# HISTORIC PRESERVATION

504 N Hackberry St  
Dignowity Hill Historic District

BOA-24-10300035

An appeal of the Historic Preservation Officer's decision to deny the wholesale replacement of existing one-over-one wood windows on the property and to modify the existing fenestration pattern.

**Before (Historic Conditions)**

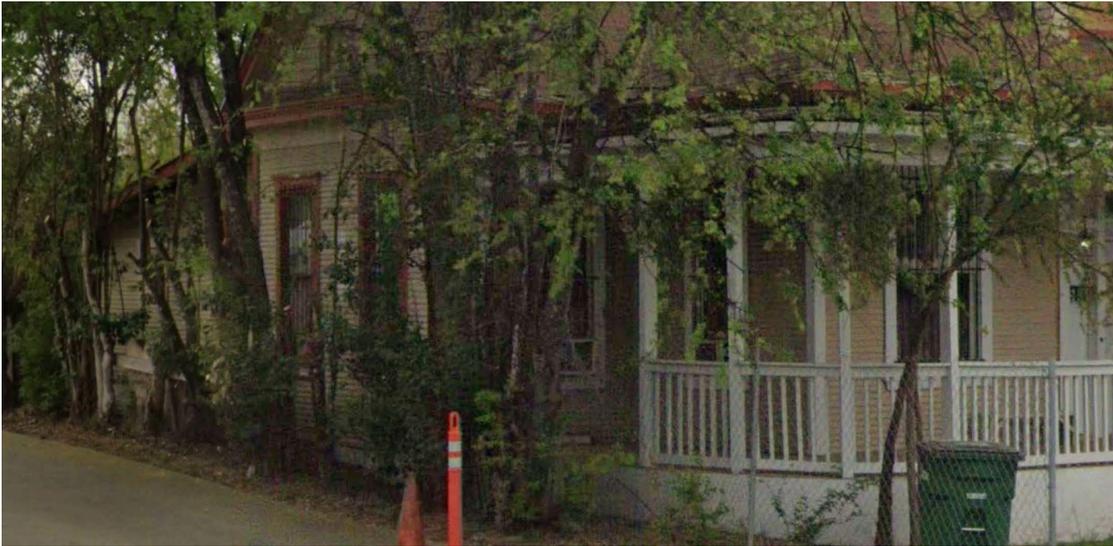
- February 5, 2024: Staff observed work occurring on the property without a Certificate of Appropriateness and beyond prior approvals. After contacting the property owner and confirming scopes of work, staff issued a stop work order on the same day. Violations included: the replacement of the original porch steps, the replacement of original porch decking, rear door replacement, skirting replacement; chimney and wood window removal; dormer vent installation; and fenestration pattern modifications, including the removal and modification of window opening sizes.

- i. FENESTRATION MODIFICATIONS (WEST) – The applicant is requesting to modify the existing window openings on the west façade. Exterior Maintenance and Alterations 6.A.i. states to preserve existing window openings and to avoid enlarging or diminishing to fit stock sizes. Staff finds the proposed modifications to the window openings on the west façade do not conform to guidelines.

- j. FENESTRATION MODIFICATIONS (SOUTH) – The applicant is requesting approval to infill three windows and modify five window openings on the south façade. Exterior Maintenance and Alterations 6.A.i. states to preserve existing window openings and to avoid enlarging or diminishing to fit stock sizes. Exterior Maintenance and Alterations 6.A.iii. states to preserve historic windows. Exterior Maintenance and Alterations 6.A.iv. states to install new windows to match the historic or existing windows in terms of size, type, configuration, material, form, appearance, and detail when original windows are deteriorated beyond repair. Staff finds the proposed fenestration modifications to the south façade does not conform to guidelines.

- k. FENESTRATION MODIFICATIONS (NORTH) – The applicant is requesting approval to infill two windows, add one window opening, and modify two window openings on the north façade. Exterior Maintenance and Alterations 6.A.i. states to preserve existing window openings and to avoid enlarging or diminishing to fit stock sizes. Exterior Maintenance and Alterations 6.A.iii. states to preserve historic windows. Exterior Maintenance and Alterations 6.A.iv. states to install new windows to match the historic or existing windows in terms of size, type, configuration, material, form, appearance, and detail when original windows are deteriorated beyond repair. Staff finds the proposed fenestration modifications to the north façade does not conform to guidelines.

Office of Historic Preservation staff does not recommend approval of the appeal. Staff recommends that the Board of Adjustment uphold the Historic and Design Review Compliance and Technical Advisory Board's and the Historic Preservation Officer's denial of a Certificate of Appropriateness for the wholesale replacement of the property's wood windows and modifications to the existing fenestration pattern.
